Errata to TFP510, Datasheet Literature Number SLDS146B

This document describes errata to the TFP510 and its datasheet.

Sheet 25, change the package figure as described:

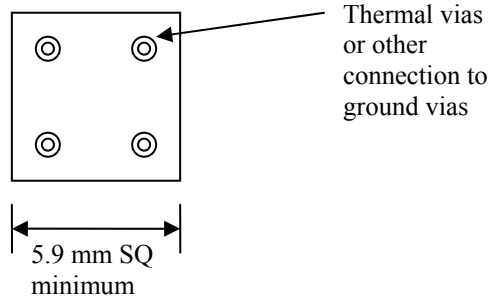
4. PowerPad size and routing consideration:

The size of the exposed metal on the PowerPad package figure is shown as larger than on production devices. When providing a thermal land, it may be smaller than assumed from the package drawing. If routing traces under the power pad, some method of protection from shorts between the traces or vias and the PowerPad should be used.

- Re-size the thermal pad dashed box from its present size to 5.35mm, centered in the package.
- Note the dimensions and change note D by either:

Add dimensions to re-sized pad showing: $\frac{5.35}{4.25}$ SQ

Change note D to read:

The package thermal performance may be enhanced by bonding the thermal pad to an external thermal plane. This pad is centered on the package and is electrically and thermally connected to the backside of the die.
